FIELD SERVICE BULLETIN

FIELD SERVICE BULLETIN NO. 21
5 August 1954

SUBJECT: RELATIVE MOTION BETWEEN FUSELAGE AND WINGS

EFFECTIVITY: ALL NAVION AIRCRAFT (MANDATORY)

AFT WING ATTACHMENT FIG. 1

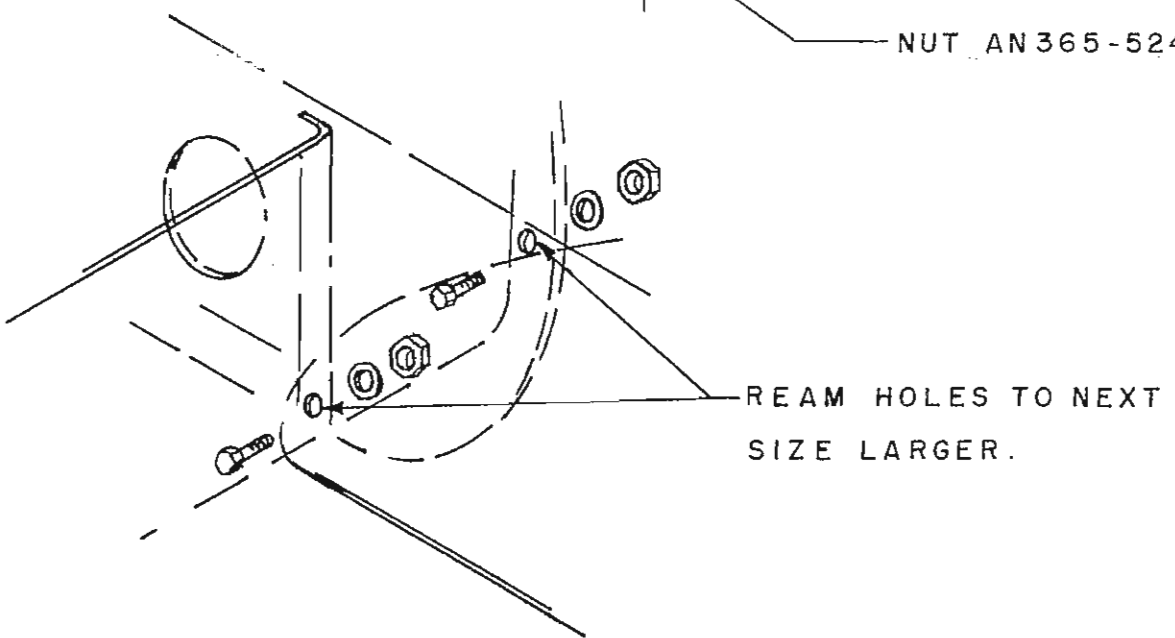
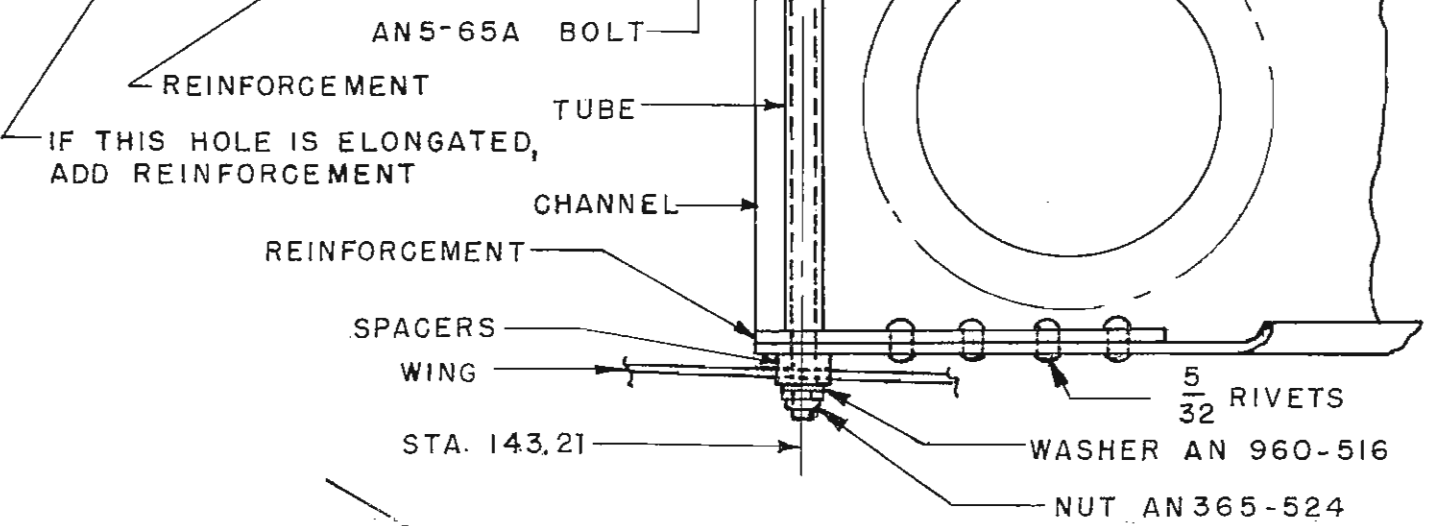
- e. Where elongated holes are evident proceed as follows.
- f. Ream holes of the four forward wing attachments to receive the next larger size bolts. Remove and replace ONLY one bolt at a time and torque to 140 inch pounds (see Figure 2).
- g. Remove the two AN5-65A aft attachment bolts, spacers, washers, tubes and nuts.
- h. Drill and attach the two .064-24ST alclad strips (see Figure 1), one on each end of the bottom inside flange of frame 142.57 and rivet each strip with four 5/32 inch rivets.
- i. Shorten the two tube spacers to fit within the channel.
- j. Install two AN5-65A bolts with nuts, washers, spacers and tubes. Torque to 140 inch pounds.
- k. Drill top wing skin at fifteen places parallel to longeron on each side of cockpit, and blind rivet the right and left .064-24ST alclad angle in place (see Figures 3, 4, 5 and 6).

FIG. 3

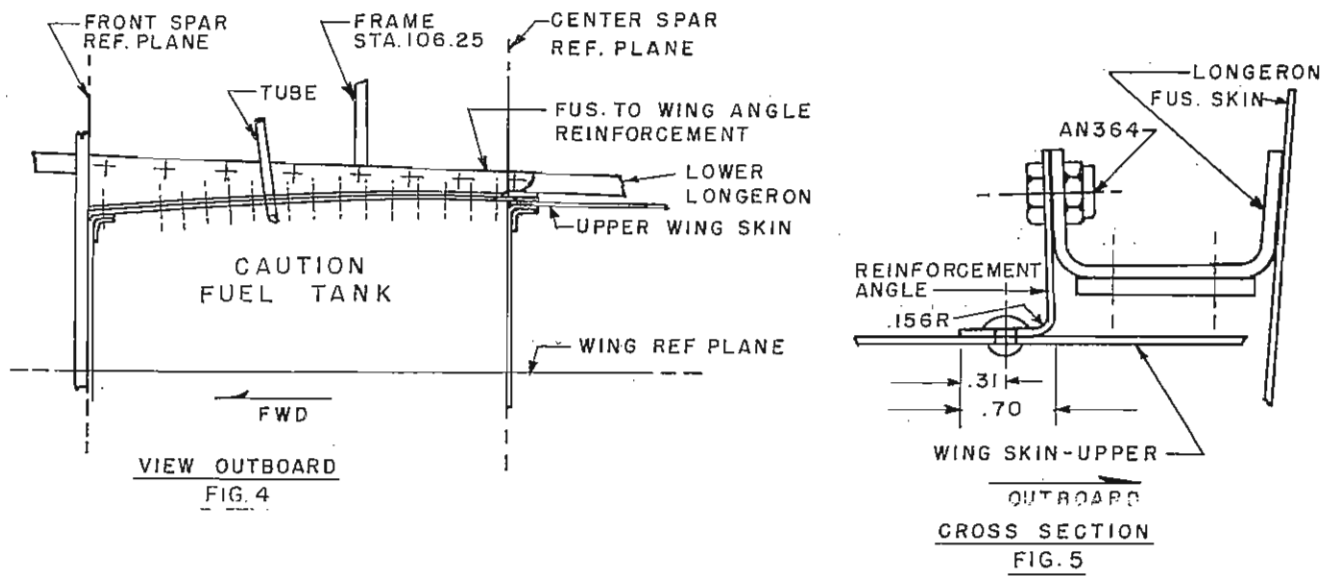
- l. Drill eight 3/16 inch holes in fuselage longerons and attach angles with AN3 bolts and AN364 nuts. Add shims between longeron and bathtub fitting on forward bolt if necessary (see Figures 3, 4, 5 and 6).
 - m. Reinstall side upholstery panels, floor mat and seats.
 - n. Attach fuel filter inspection plate and wing tillets.
4. Parts may be locally manufactured from information furnished in this bulletin or procured in kit form at nominal cost from
